ORIGINATION FORM

Proposed Revisions to a Standard Plans Index
(Please provide all information — Incomplete forms will be returned)

Index Number: 715-001
Sheet Number (s): 1
Index Title: Conventional Lighting

METAL POLE WIRING DETAIL

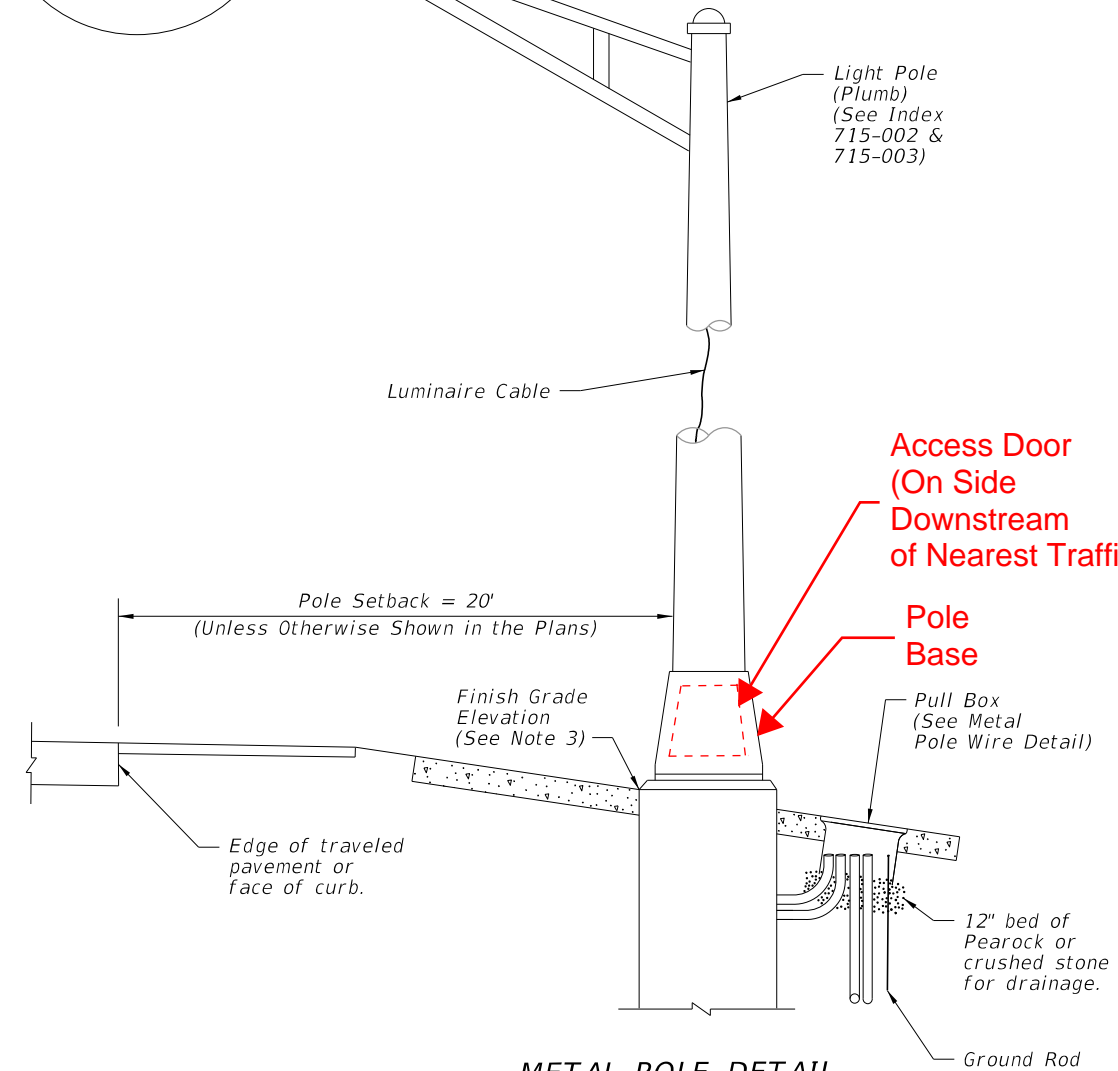
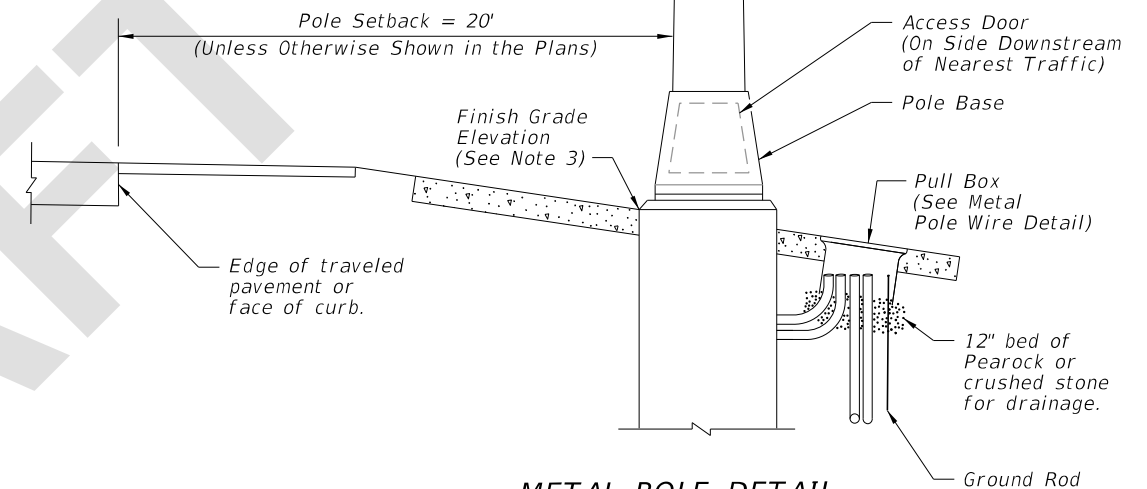
Sheet 1: Deleted the "Access Panel" drawing and added a "Pole Base" callout on the 'Metal Pole Wiring Detail'.
Added the "Access Door" drawing and a "Pole Base" callout on the 'Metal Pole Detail'.

The details were revised to locate the Access Door on the downstream side of the Pole Base for better consistency with Standard Specifications 715-13.1. The downstream side is relative to the nearest traffic movement.
